AP1000 TECHNICAL REPORT REVIEW

Response to Request For Additional Information (RAI)

7.3.1.2.17 Control Room Isolation and Air Supply Initiation

DCD Figure 9.4.1-1 (Sheet 1 of 7)

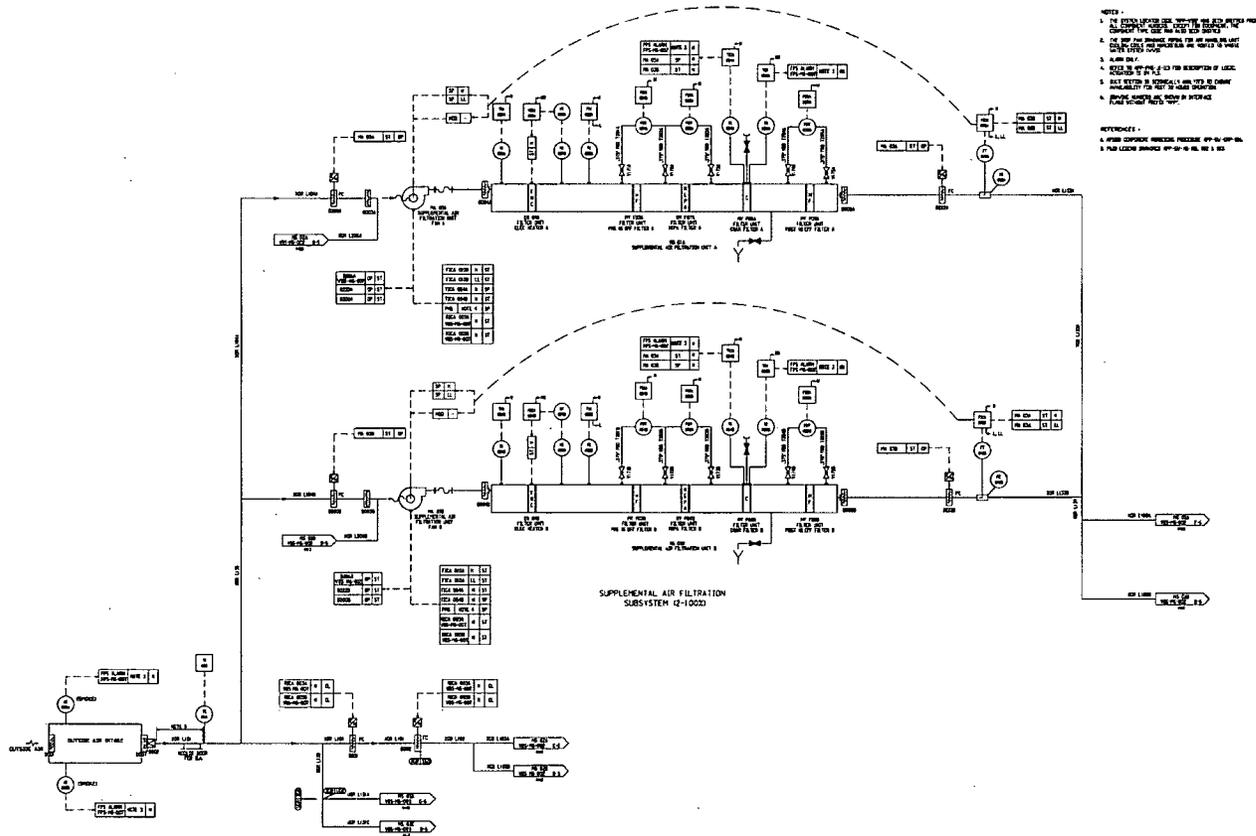
If "high" gaseous radioactivity is detected in the main control room supply air duct and the main control room/control support area HVAC subsystem is operable, both supplemental air filtration units automatically start to pressurize the main control room and CSA areas to at least 1/8 inch wg with respect to the surrounding areas and the outside environment using filtered makeup air. ~~After the room is pressurized, one of the supplemental air filtration units is manually shut down.~~ The normal outside air makeup duct and the main control room and control support area toilet exhaust duct isolation dampers close. The smoke/purge exhaust isolation dampers close, if open. The main control room/control support area supply air handling unit continues to provide cooling with recirculation air to maintain the main control room passive heat sink below its initial ambient air design temperature and maintains the main control room and CSA areas within their design temperatures. The supplemental air filtration subsystem pressurizes the combined volume of the main control room and control support area concurrently with filtered outside air. A portion of the recirculation air from the main control room and control support area is also filtered for cleanup of airborne radioactivity. The main control room/control support area HVAC equipment and

ductwork that form an extension of the main control room/control support area pressure boundary limit the overall infiltration (negative operating pressure) and exfiltration (positive operating pressure) rates to those values shown in Table 9.4.1-1. Based on these values, the system is designed to maintain personnel doses within allowable General Design Criteria (GDC) 19 limits during design basis accidents in both the main control room and the control support area.
